ENGINE - FUEL AND CONTROL - REPLACE THE TUBE AT CLIPPING POINT 0306 - 4 -
MOD.ENG-73-0022

V2500-ENG-73-0022

Location at clipping point CP0306 - Before alteration
Fig.2

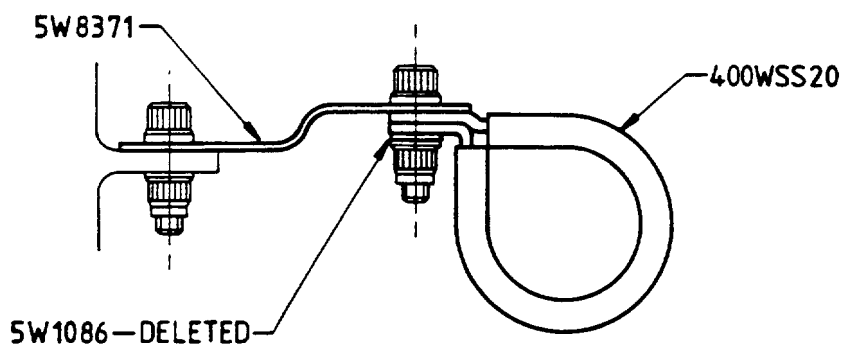
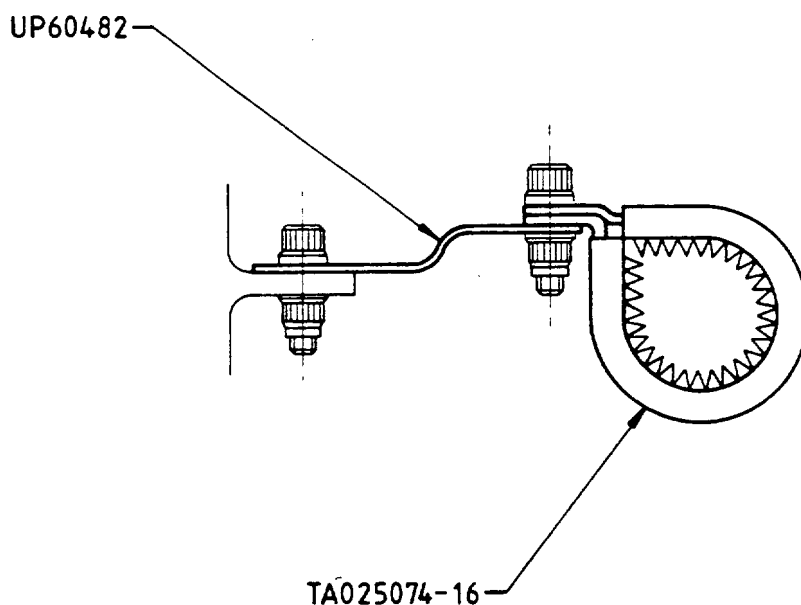
- (1) A tube clamp with a thicker rubber sleeve replaces the existing clip at clipping point 0306. The new clamp has a tighter fit with the tube compared to the existing clip.
- (2) A new mounting bracket is introduced at clipping point 0306 to provide increased clearance for the clamp. Existing brackets can be reworked.
- (3) the washer at clipping point 0306 is deleted to accommodate the new clamp and modified bracket.

- (1) Secure bracket UP60482 to flange FC with bolt 4W0163 (2 off) and nuts 4W0002 (2 off).
- (2) Fit clamp TA025074-16 to the fuel pump to F.C.O.C. tube and secure at clipping point 0306 using bolt 4W0102 and nut 4W0001 (refer to Fig.3).

Rework existing mounting bracket
Fig.4

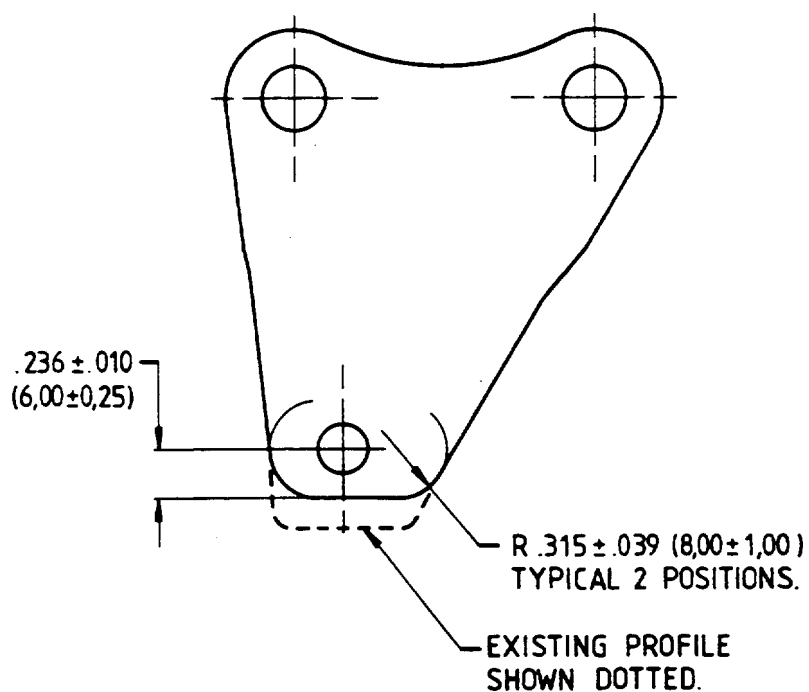
Rework 5W8371, bracket as follows:

| (a) Remove material from bracket | Refer to Figure 4.
| (b) Remove burrs from bracket | Refer to Figure 4.
| (c) Visually/dimensionally inspect | Refer to Figure 4 |

REMOVE THE SHARP EDGES $.012 \pm .008$ (0,30 \pm 0,20).
DIMENSIONS ARE IN INCHES WITH MILLIMETRE CONVERSIONS IN PARENTHESES.
